# A428 Black Cat to Caxton Gibbet improvements

9.55 Applicant's response to Cambridgeshire County Council's  
comments on archaeological mitigation areas

**9.55 Applicant's response to Cambridgeshire County Council's  
comments on archaeological mitigation areas**

<b>Regulation Reference:</b>	Rule 8(1)(k)
<b>Planning Inspectorate Scheme Reference</b>	TR010044
<b>Application Document Reference</b>	TR010044/EXAM/9.55
<b>Author</b>	A428 Black Cat to Caxton Gibbet Improvements Project Team, National Highways

Site Number and Field Number	CCC Position	Applicant Position
	 <p>Plate 13 Proposed CCC Area Site 19</p>	 <p>Plate 14 AMS Area Site 19</p>

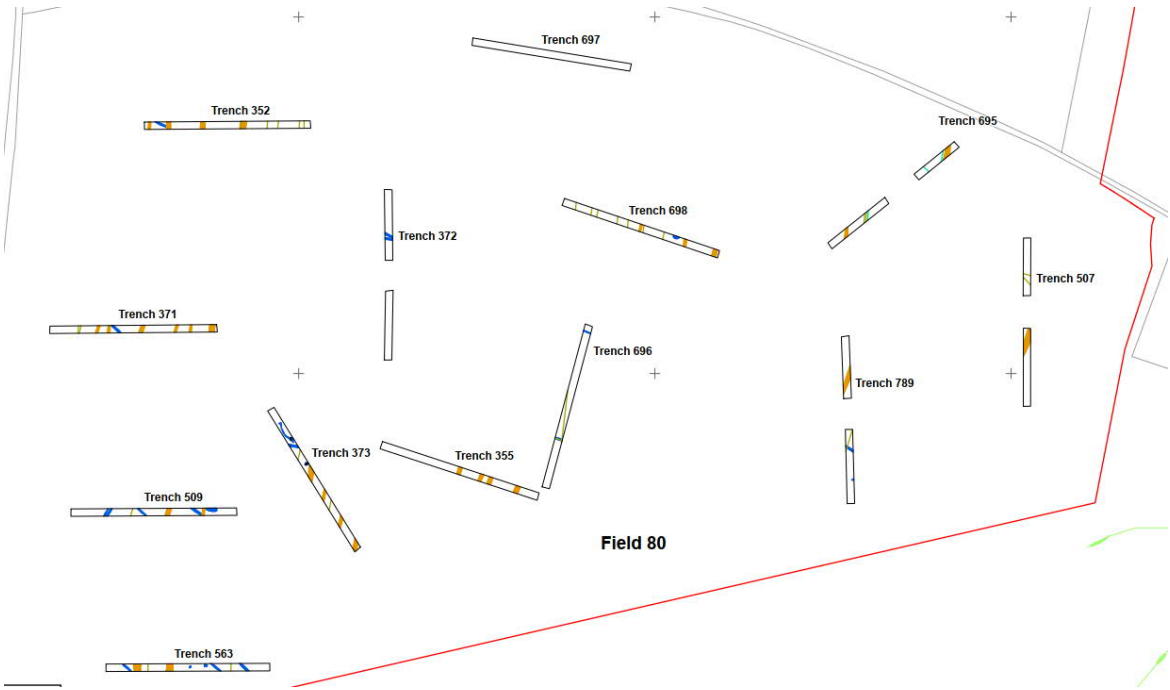
Site Number and Field Number	CCC Position	Applicant Position
The cSite 19, Fields 58 & 62	<p>Deep colluvial and alluvial soil deposits associated with Hen Brook and the impact of cultivation (possibly Medieval but could be earlier) were seen in the evaluation trenches to seal old land surface soils and cut feature evidence (as well as tree boles). If the relationship of sites to water courses and water sources is to be understood, an area previously discussed with the A428 archaeological team should be stripped for examination around the brook. The stripped area should be extended southwards to include a round house found in Field 58 by geophysical survey and tested in the evaluation. More, similar remains may be present as the wider archaeological evidence (geophysical survey and air photos) indicate association with the more extensive settlement evinced in Field 60 outside the Order Limits, on the SE side of the current A428 and in Wintringham Park (WP Site 2, A428 Site 14). It is likely that this is riverside settlement.</p> <p>Palaeochannels and old land surface soils that may be present must be subject to a full suite of palaeoenvironmental sampling measures to enable the signature of past human environments to be established. This is a requirement of the JAAB and is rehearsed in the research objectives at 4.4.8 and 4.4.11c and d.</p>	<p>This mitigation area is proposed for geoarchaeological and palaeoenvironmental assessment. Section 10 of the AMS details the requirements for geoarchaeological and palaeoenvironmental assessment. Section 10.2.10 includes a requirement to strip soil to reveal archaeological features sealed by the colluvium. The AMS also requires a Site Specific WSI to be prepared by the Archaeological Contractor for approval by CCC. A suitably experienced geoarchaeologist must be involved in this process.</p> <p>There is no justification to extend the excavation to the south to cover the ring ditch. Excavation of the feature would not meet the research aims detailed in Section 4 of the AMS, as it is shallow (at 0.22m). There would be no further knowledge gain from its excavation as its form is recorded on the geophysical survey, and it is understood as the shallow, heavily ploughed remains of an Iron Age roundhouse. No further information will be gained from further excavation and there is no public benefit from excavating it.</p> <p>Wintringham Park Site 2 is not a riverside settlement, but rather a Middle Iron Age settlement located on a north-south driveway. There was no evidence that it was focused on Hen Beck, either from the evaluations undertaken by both of the archaeological contractors, MOLA and Oxford Archaeology East, analysis of aerial photography or the geophysical survey. Indeed, all of the settlements from Loves Farm, south beyond Hen Brook, are on the higher ridges of ground and have not been attested beside the becks. This was reinforced by the extensive A428 evaluations, comprising geophysical survey and aerial photographic analysis, and 14 evaluation trenches to the south of Hen Brook in Field 58 (south of the colluvium indicated by the dashed orange line on Plate 13) and north of the enclosure forming Site 13, and others to the north of the brook, but the only feature was the shallow ring ditch 1214. A former field boundary and minor features related to this were also noted. As a consequence there is no justification to extend the mitigation area.</p> <p>Please note that the mitigation area may be extended westwards along the Brook where an access track is proposed. The construction methodology is awaited from the Principal Contractor for this area. This is needed so the impact on the colluvial deposits can be assessed to determine if the area will require mitigation. This is a separate area to that proposed by CCC on Plate 13.</p>

Plate 19 Proposed CCC Area Site 26

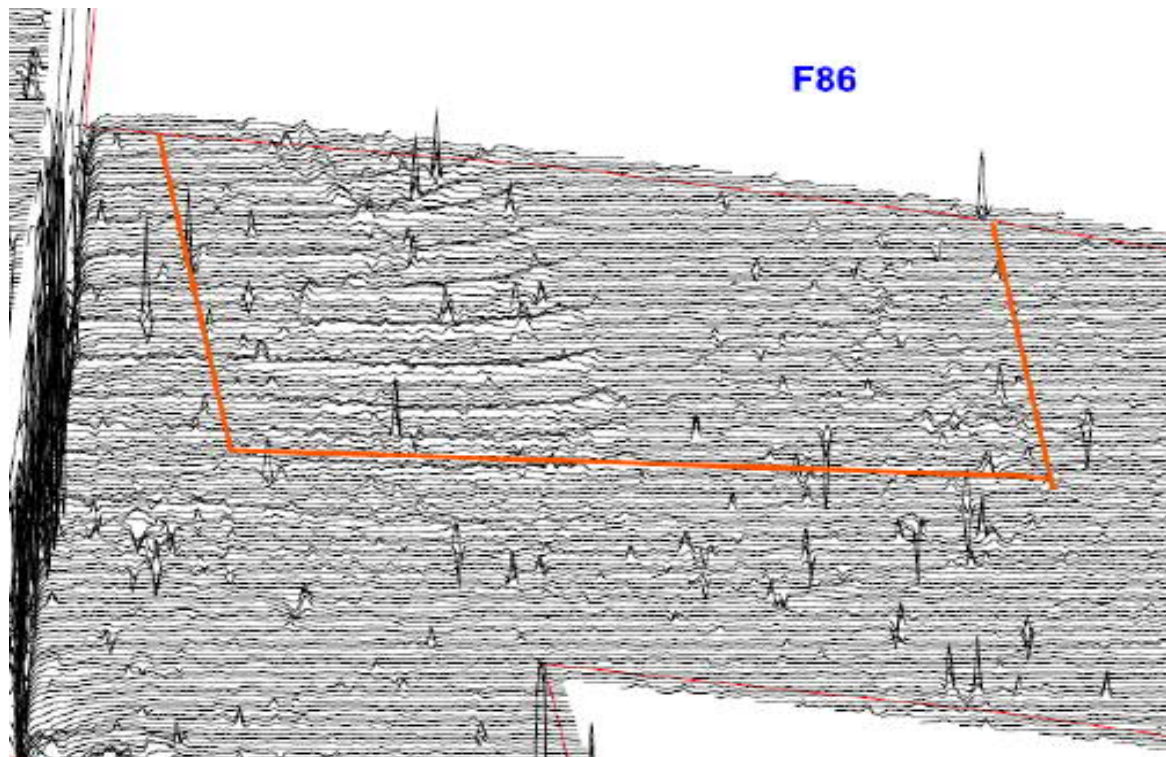
Site Number and Field Number	CCC Position	Applicant Position
Site 26, Field 86	<p>The excavation box is very tight to the fragmentary evidence revealed in the geophysical survey. We have recommended widening a short distance. it to allow for a clearer view of the limits of the settlement evidence.</p> <p>The proposed strategy – to sample excavate the site may be too little for the evidence. Flexibility to scale up the intensity of excavation should be enabled.</p>	<p>There is no justification to extend the area or to undertake more than targeted excavation. The geophysical survey indicates that this is the south-west corner of a ditch that is on the northern edge of the Order Limits. The extent of the feature will be incorporated within the area proposed and the course of the feature was recognised in the evaluation report. A trench was excavated during the evaluation (Trench 8) to the east and Trench 701 was excavated to the west. Neither of these trenches contained any features other than furrows. No Iron Age remains extend this far and it is not commensurate with the available evidence to extend the area. There is a clear picture over the limit of the archaeological evidence here. The site is located at the southern limit of the Iron Age enclosure and the boundary.</p>

Site Number and Field Number	CCC Position	Applicant Position
	<div><p>Plate 22 Proposed CCC Area Site 28 (November 2020)</p></div>	<div><p>Plate 23 AMS Area Site 28</p></div>

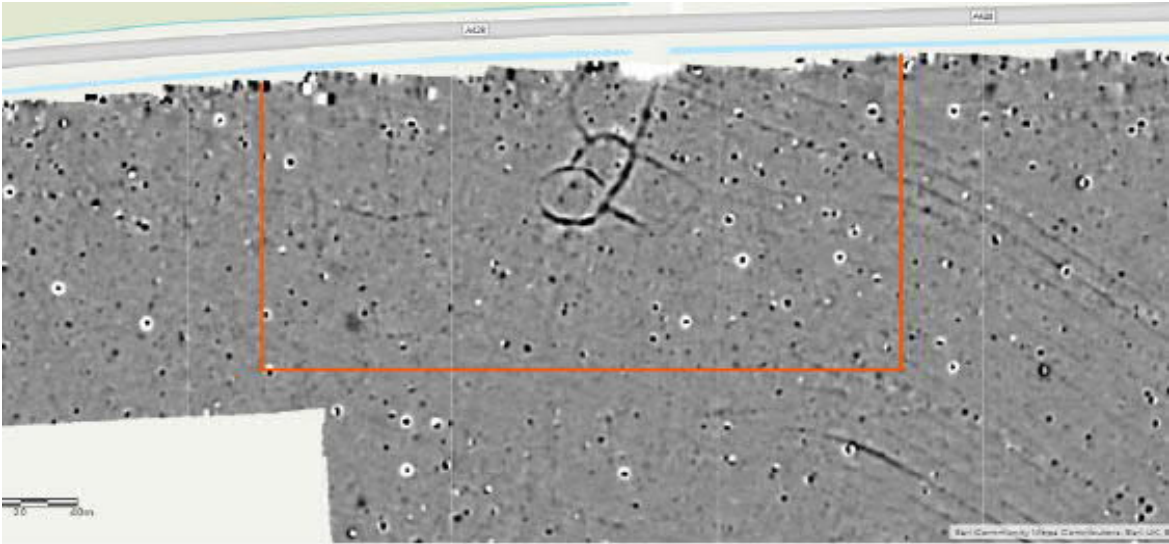
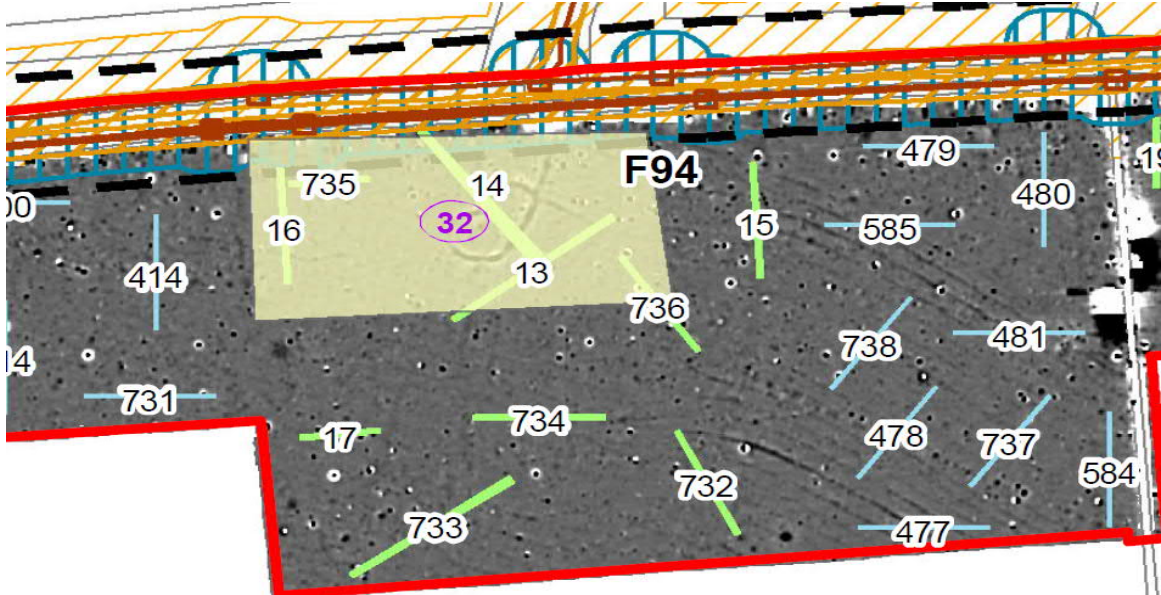
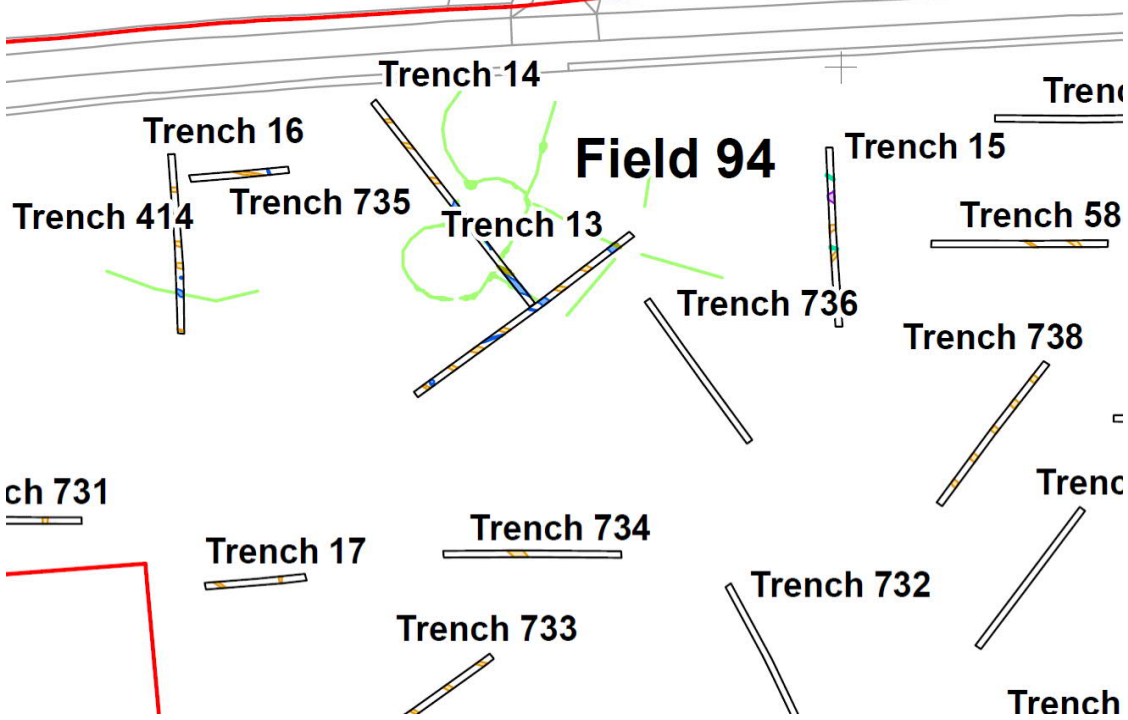
Site Number and Field Number	CCC Position	Applicant Position
Site 28, Field 90	<p>This site has been miscategorised for sample excavation, yet the new site form of enclosures linked to a string boundary should be classed in category b – Group Value. A form of site recognised by research conducted on the clay landscape of the A14 excavations, industrial and craft activities were found to take place beyond the boundary, where houses and paddocks saw close enclosure along sinuous ditches.</p> <p>The site in Field 90 appears to have elements extending into Field 92, across the B1040, the St Ives Road, in which Iron Age and Roman settlement is present. A small excavation link to the east has been recommended to enable these sites to be properly mapped and recorded prior to removal through construction impact, and to the west to encompass geophysical anomalies for which further exploration is required.</p> <p>The maplet in Appendix D is also not approved.</p>	<p>CCC state that elements of this site extend into Field 92 to the east. This appears to be based on a feature CCC have identified on the geophysical X-Y plot that is not apparent to the geophysical team or the A428 team. However, even if this feature survives, it would be picked up in both the Field 90 (Site 28) and Field 92 (Site 30) mitigation areas.</p> <p>There is no justification for the extended area proposed by CCC. There were no archaeological remains in the trenches in that area. Trenches 401 contained only furrows while 577 contained two undated pits. Extension into this area is not warranted. The strategy of targeted excavation at this site will strip an area of 1.52ha along the length of this boundary and examine the relationships of any linking ditches and the circular structures. There is no merit in exposing any further areas where the string boundary potentially extends. As stated in the evaluation report, “further investigation into the boundary itself is unlikely to provide any additional information to what has already been recorded” (Appendix 6.6 paragraph 7.4.14) <b>[APP-173]</b>, so extension of the area southwards will not add to the corpus of knowledge.</p> <p>In the southern part of the field, adjacent to the existing A428, where CCC have requested an additional area in October 2021 to be added to the mitigation area, there were again few features located. One undated ditch section was seen in Trench 580, while other trenches in this area only contained furrows. As such, extending the area is not justified. The map shown in Appendix D of the AMS (see also Plate 24 below) will not be updated.</p>

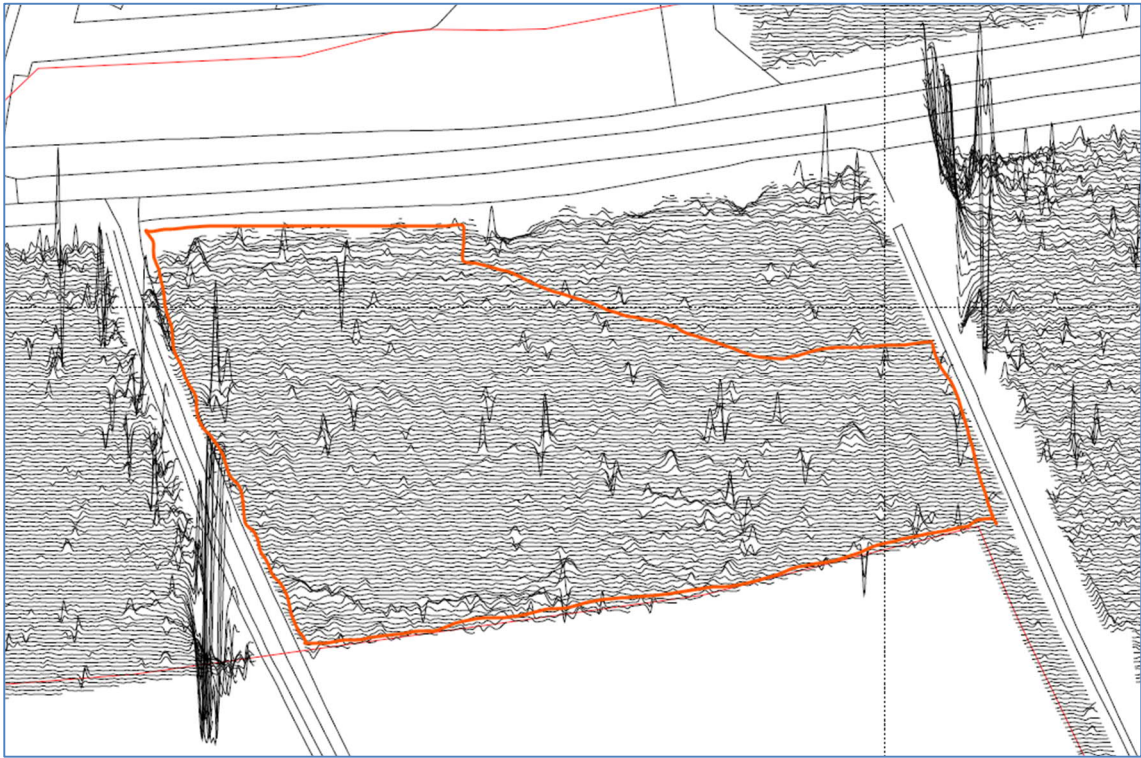
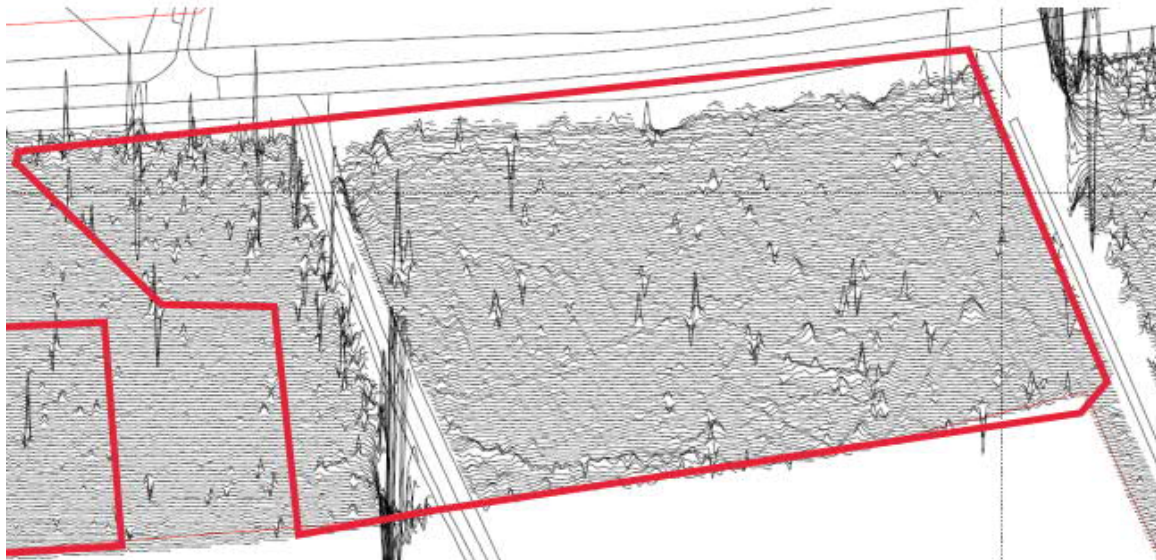
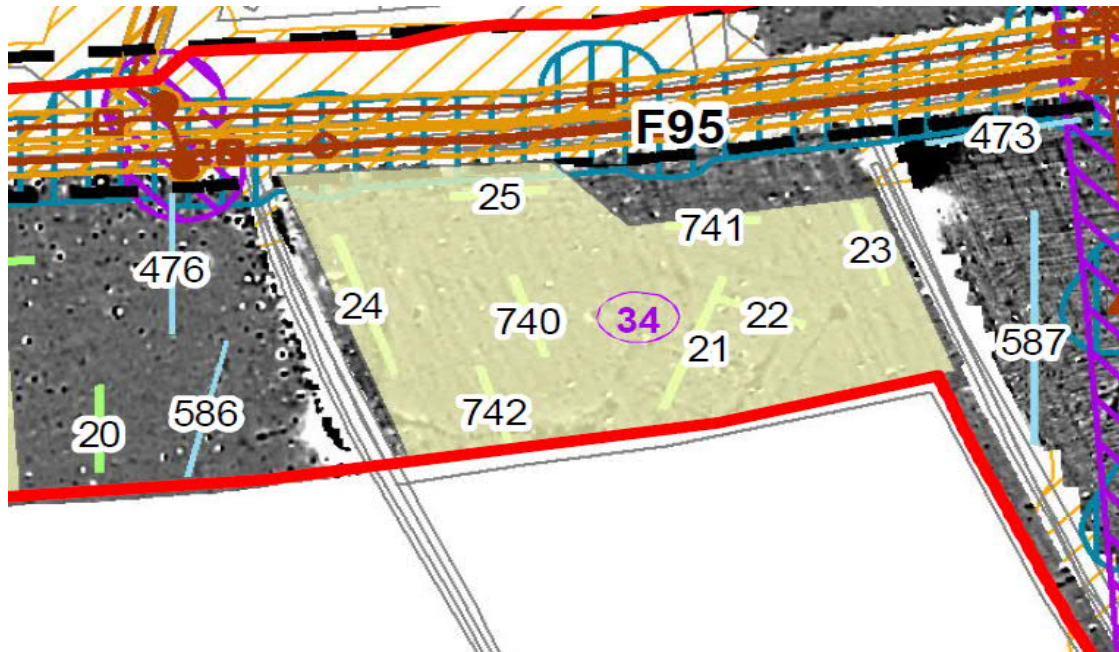
Site Number and Field Number	CCC Position	Applicant Position
Site 32, Field 94	Group Value category b is approved. The excavation box shown in Appendix D is not: it requires extending southwards to encompass further contemporary evidence and test the geophysical anomalies.	There is no justification to extend this area. Trench 15 to the east contained only furrows, as did Trenches 17, 734 and 733 to the south. Trench 414 to the west also contained only furrows. We are therefore confident that we have captured remains associated with the enclosures. All geophysical anomalies identified on the geophysical survey in this area are included within the mitigation area. The site is being considered for its group value and association with other Middle Iron Age and later sites to the east (Sites 33-39).

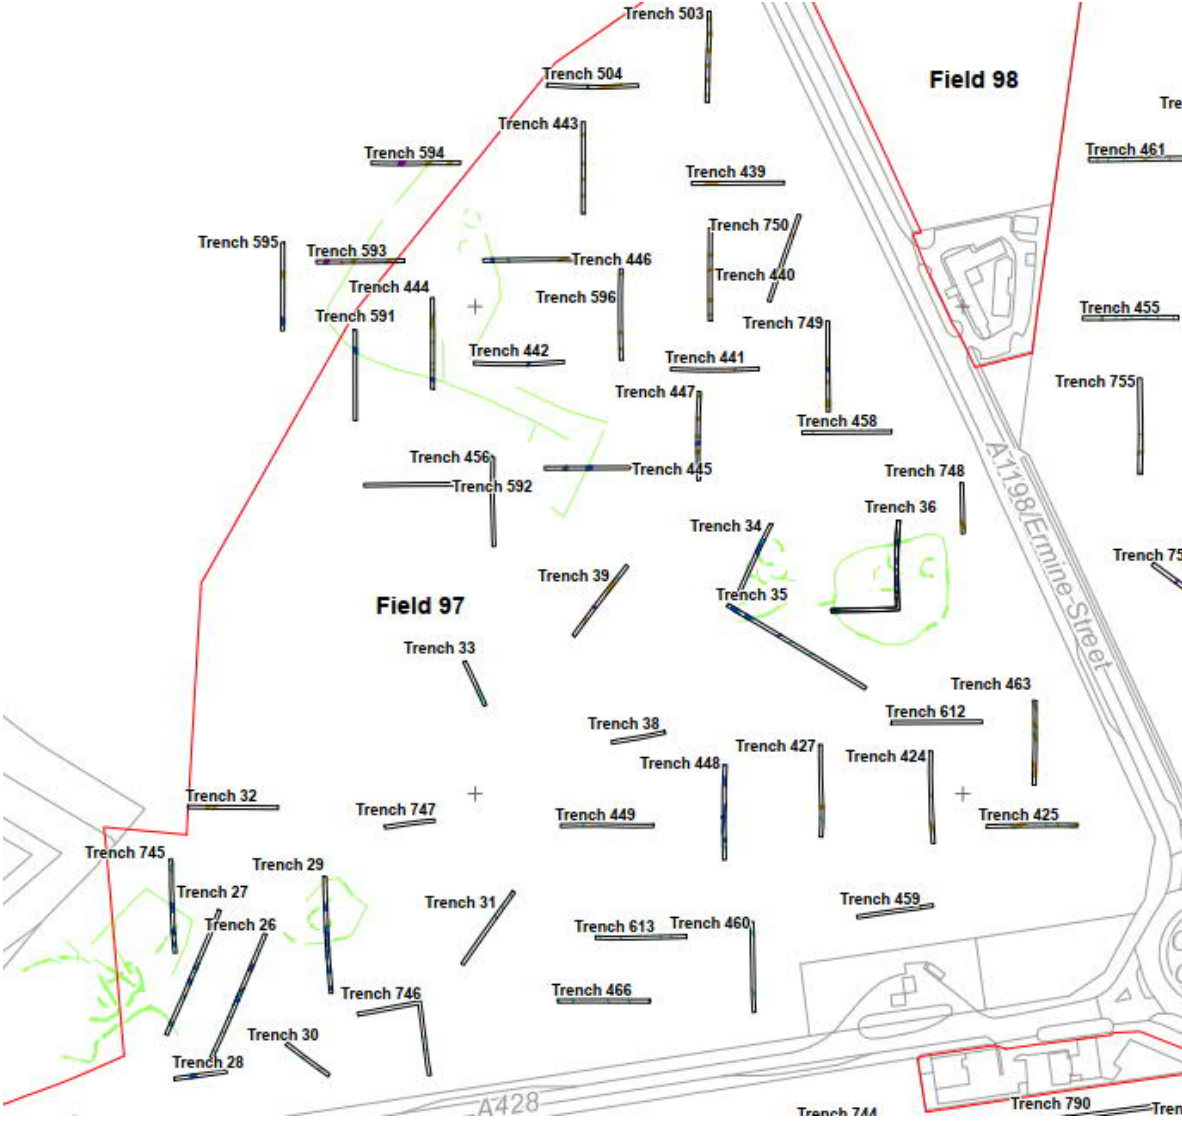
Site Number and Field Number	CCC Position	Applicant Position
Site 34, Fields 95 & 96	<p>Not approved.</p> <p>There is a major mapping error for this site at the east end of the scheme north of the Scheduled Monument Pastures Farm (NHLE 1019177). Despite the description indicating that the archaeological site is located in two fields on the south side of Cambridge Road, the maplet shows only one excavation area (in Field 95) that should cover the whole field within the Order Limits.</p> <p>The second area in Field 96 is entirely missing. This should extend to cover the parallel ditches bounding the enclosures into Field 96 that extend SE to contemporary remains. They appear to be roadside ditches and may have a relationship with Ermine Street Roman Road on the east side of the field.</p> <p>Also omitted are the multiple parish boundary ditches in the north part of the field that proved difficult to excavate in the wet conditions of February 2020. The examination of the antiquity of parish boundary features and their reestablishments should be included in the research objectives list.</p>	<p>The area to be fenced off in Field 96 is missing and the map will be updated. This will be included in an updated AMS submitted at Deadline 4 [TR010044/EXAM/9.23 v2]. The majority of the archaeological remains in this field is within the southern part of the field. This was originally proposed for diversion of overhead lines – this is no longer needed. This has previously been communicated to CCC.</p> <p>It is not clear which parallel ditches CCC are referring to. We believe that these are in the area to be fenced off.</p> <p>The parish boundary was excavated in Trenches 464 and 465 and a plan of its alignment drawn in Trenches 472 and 473. This concluded:</p> <p>“The former parish boundary between Caxton and Papworth Everard was parallel to the present A428 road at the north end of Field 96 and was present in Trenches 464, 465, 472 and 473... The ditch was up to 1.4m wide by 0.6m deep and was U-shaped in profile with a tapered rounded base. Approximately 500m of the parish boundary is within the field, as identified through geophysical survey. The parish boundary is marked on the Old Series First Edition Ordnance Survey map of 1805 and on later OS maps, including the 1887, 1:2500 scale County Series maps for Cambridgeshire and Huntingdonshire. No finds were present in the ditch so the origins of the boundary cannot be traced earlier than the beginning of the 19th century. However, it is probably older than this.”</p> <p>Based on this evidence it is not apparent that any further information would be gained.</p> <p>Note that the area of Field 95 was extended to match the area requested by CCC on 15 October 2020. CCC later asked for a further amendment to cover the entire field on 4 November 2020 without clear reasoning. There is no justification to extend this site, based on the excavation results where the parish boundary was investigated during the evaluation and that no further information will be gained from further excavation.</p>
